Federal Register

[Docket No. FAA-2019-0715; Product Identifier 2019-NM-151-AD; Amendment 39-19760; AD 2019-20-07]

Airworthiness Directives; The Boeing Company Airplanes

ACTION: Final rule; request for comments.

Figure 2 (Sheet 2 of 3) Slat and Flap Inspection

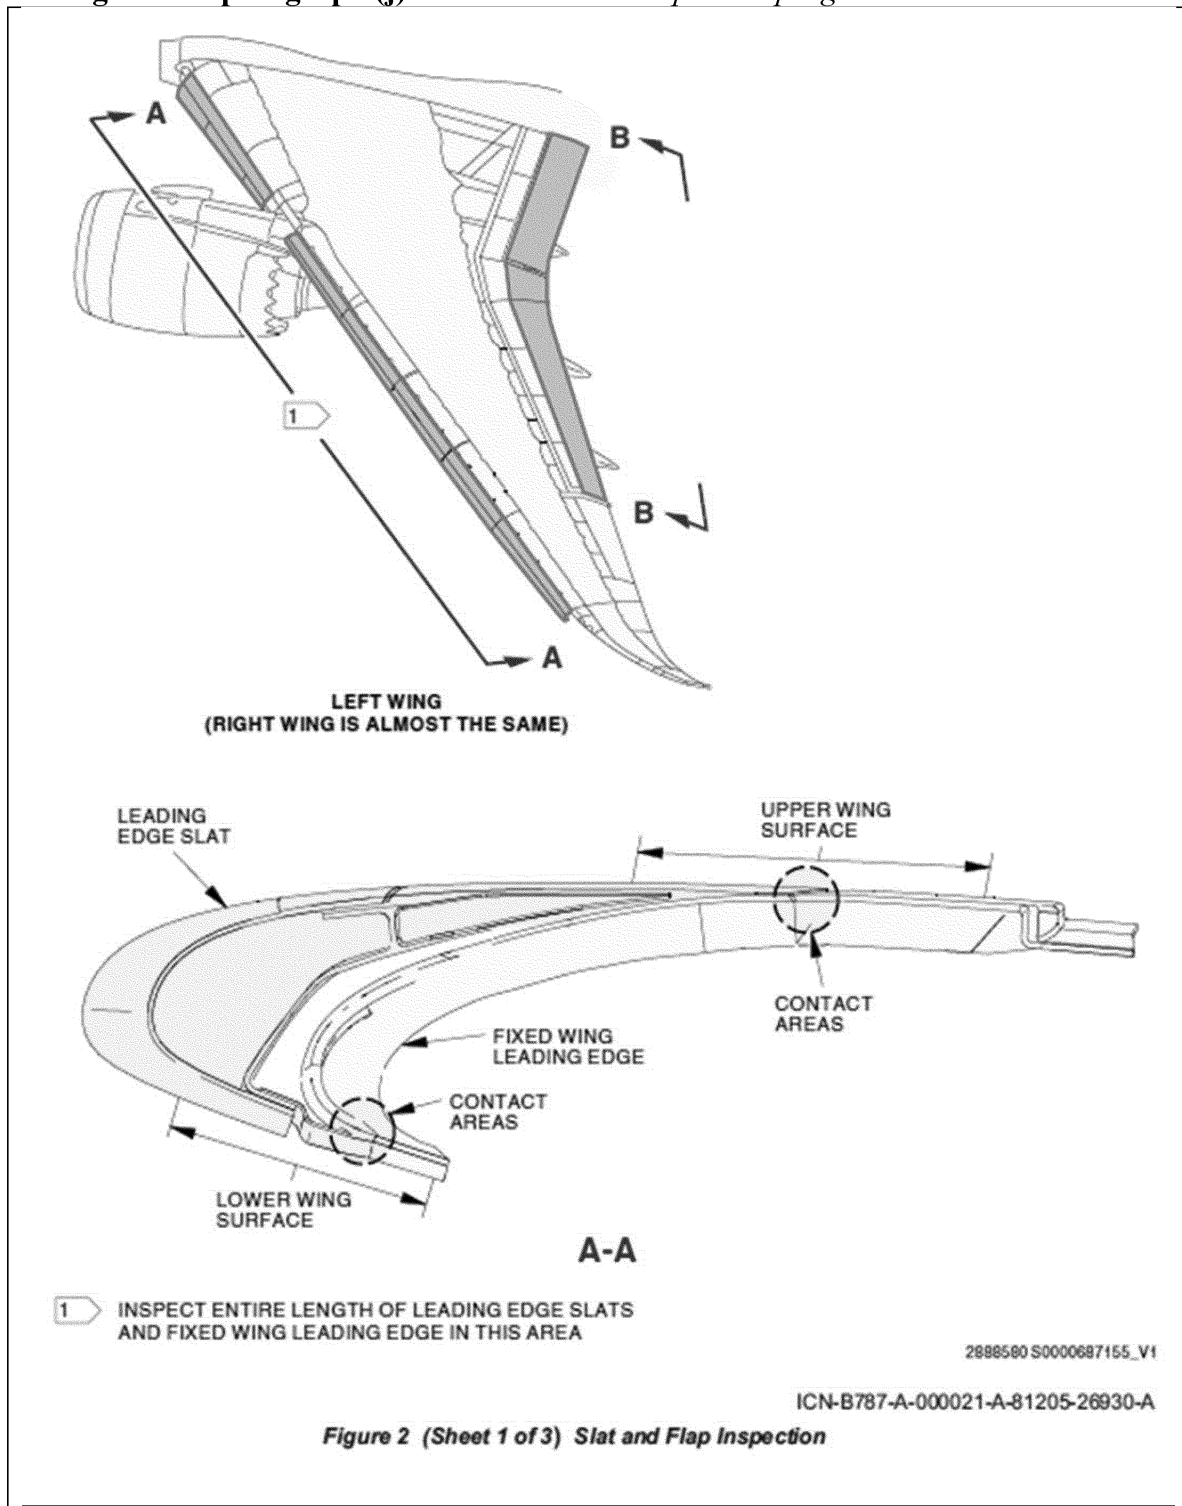
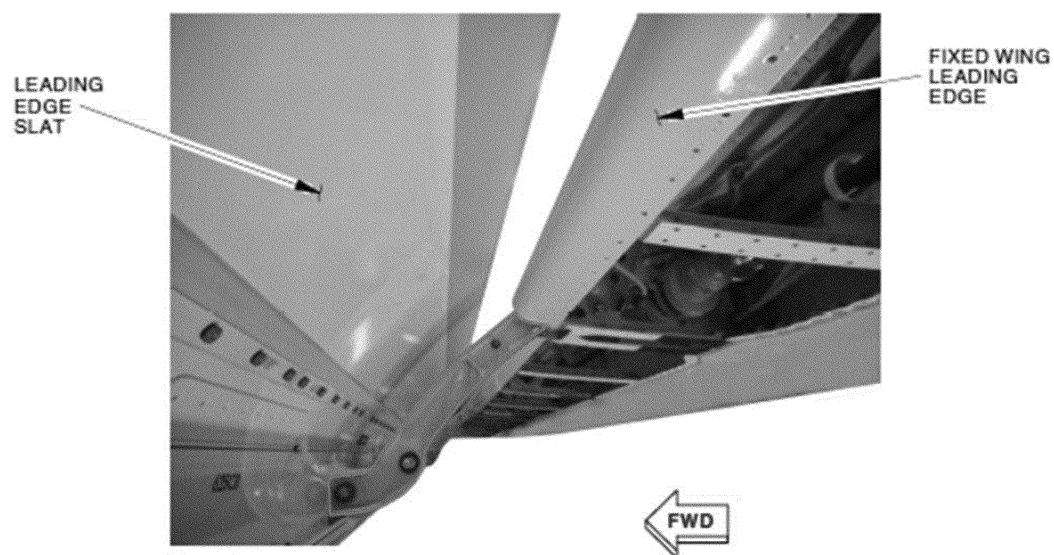
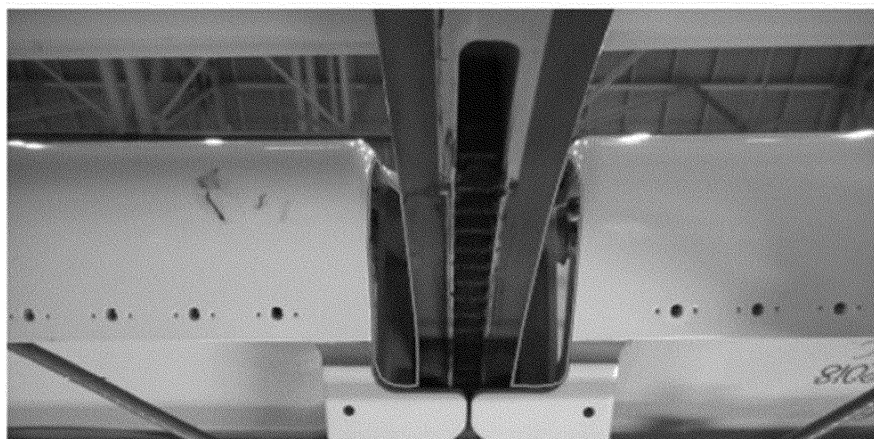
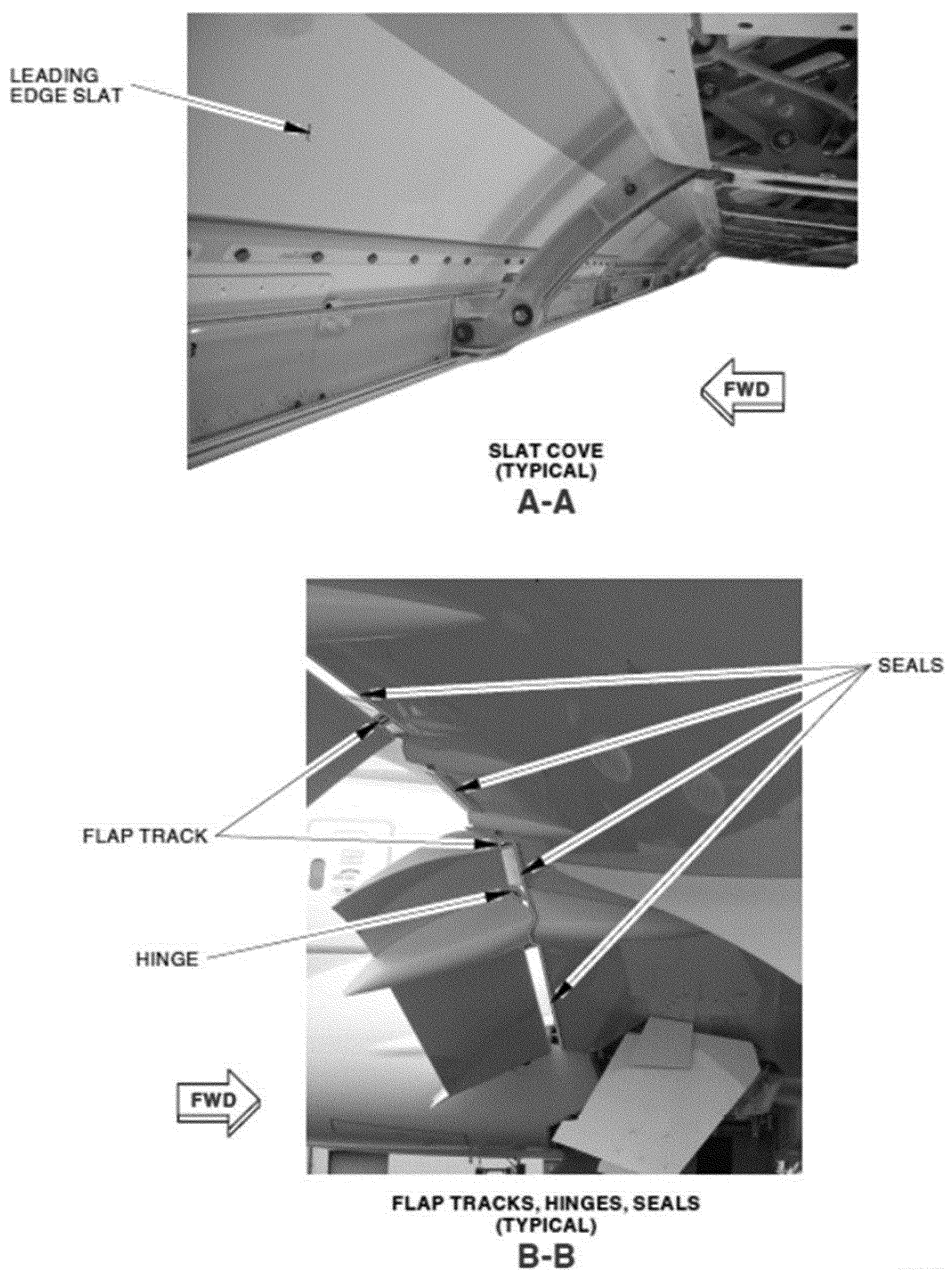
inspection program, as applicable, to incorporate the information specified in figure 2 to paragraph (j) of this AD. This may be done by inserting a copy of figure 2 to

After any landing in icing conditions, do this inspection with the slats/flaps (flaps 25 detent) fully extended (Figure 2):

- (a) Examine these areas for contaminants (ice, snow, slush):

- 3) Slat actuation areas, including exposed areas of the slat track cavity, and slat cove
- 4) Flap tracks, hinges, seals
